Submission Objecting to the Berrima Hotel Project

The proposed project is objected to on the following four grounds:

Figure 18. Key public viewpoints
Source: Nearmap and Ethos Urban

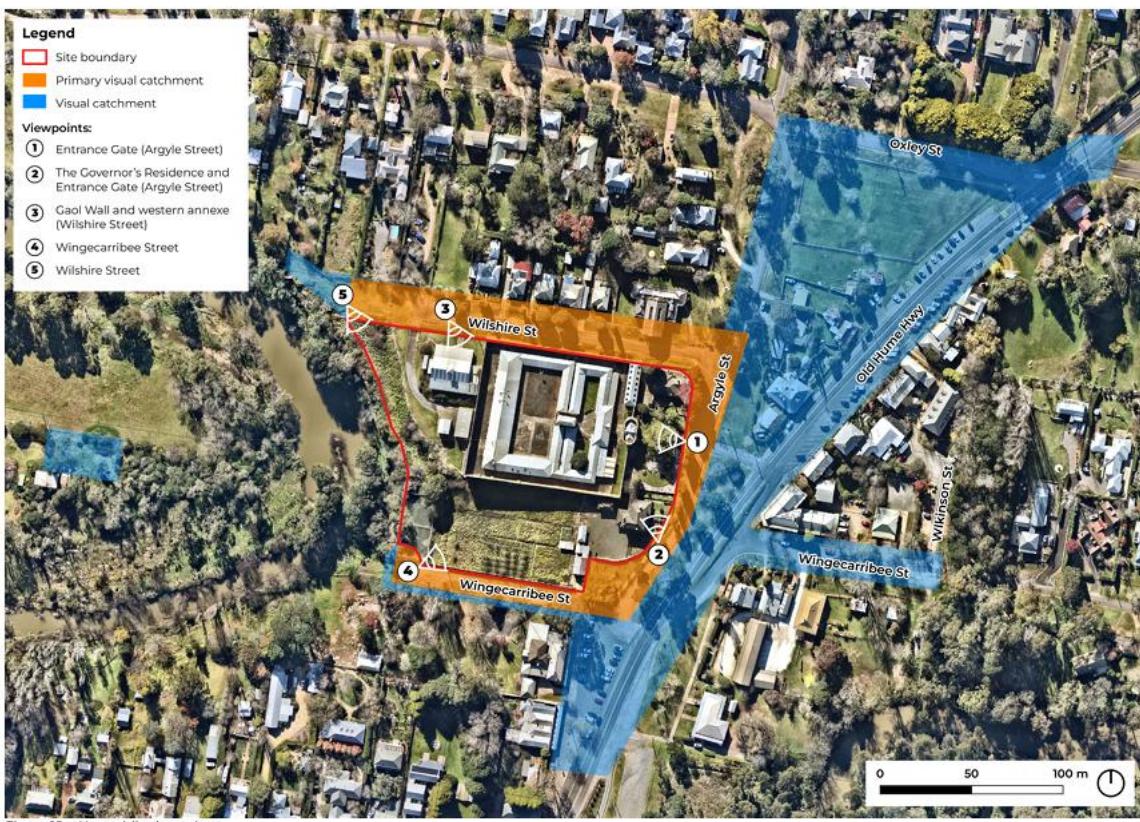
- The VIA is deficient as the 5 Viewpoints outlined on page 41 of the VIA:

do not adequately address one of the four identified primary visual catchments “west: Wingecarribee River” as none of the 5 Viewpoints are from the western side of the Wingecarribee River, a vantage point for both residents and visitors accessing the reserve and river walk on that side of the River.

- Without this assessment the VIA does not have the data required to reach a properly informed Conclusion, the VIA therefore should not have reached a Conclusion, and the Conclusion reached in the VIA cannot be relied upon.
